RE: Sign Permit - File O2SP-23 Request for Sign Exception

RE: Sign Permit - File 02SP-23

The following is the response to each incomplete criteria as described by the letter dated August 16<sup>th</sup>. Please find responses and the required additional information below.

DESCRIPTION		
PSX 30' HEIGHT X 5' APPROX. 2P IL DF PYLON SIGN		
DRAWN BY:	CHECKED BY:	
S.PATTERSON		
CLIENT:	76	
LOCATION:	913423	
QUOTE:	DATE:	
379017	09/08/23	
DRAWING/PART #	REV.	SHEET #
PSXP30054-KIT	A	1 OF 2

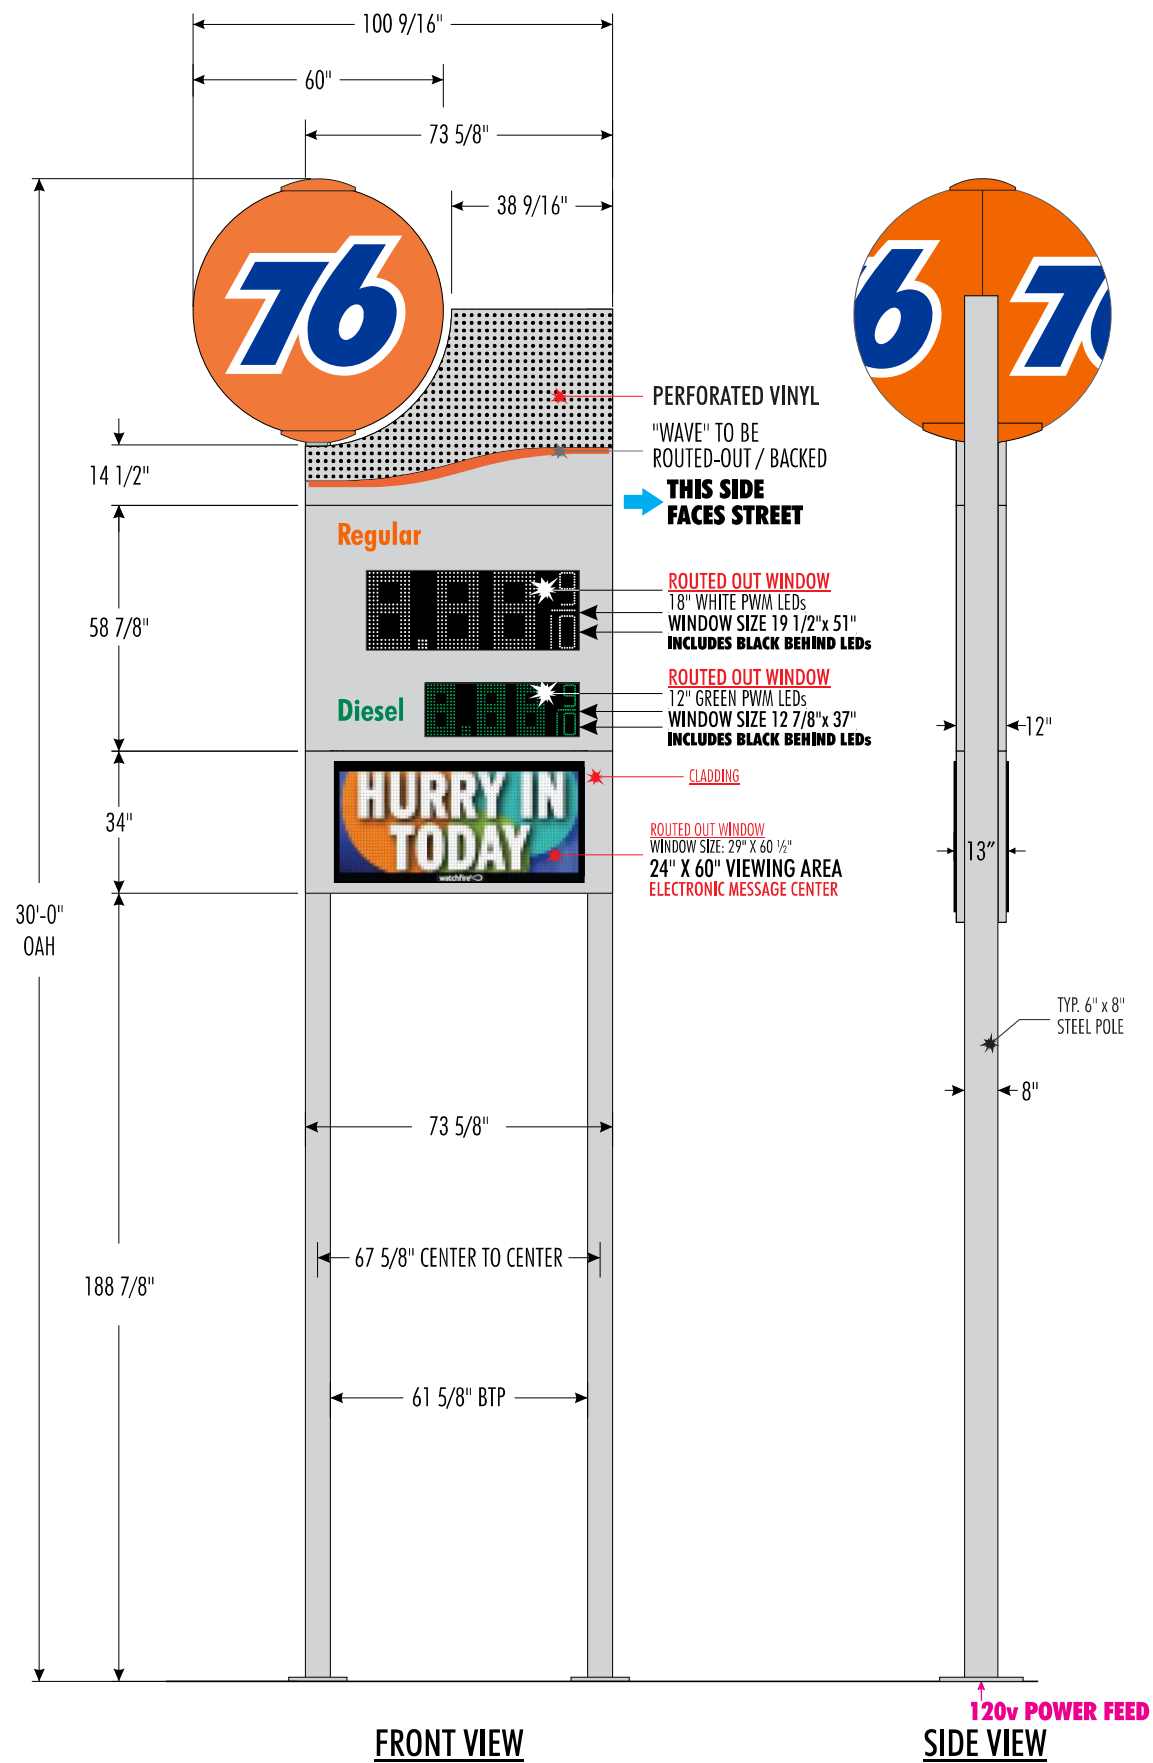
The plans you provided indicated that the bottom edge of the sign face for the freestanding sign would be roughly 7.5 feet from the ground. This would meet the definition of a ground mounted sign which would only be allowed to be 12 feet in height. You've proposed your to be 22 or 24 feet in height (the site plan differs from what was listed in the application). Please revise the design to meet the requirements of the code and provide an accurate proposed height.

**Response: The freestanding sign has been redesigned and we are requesting a special exception on the height of the freestanding sign. This will be addressed in a separate letter.**

**Response: The freestanding sign has been redesigned and we are requesting a special exception on the height of the freestanding sign. This will be addressed in a separate letter.**
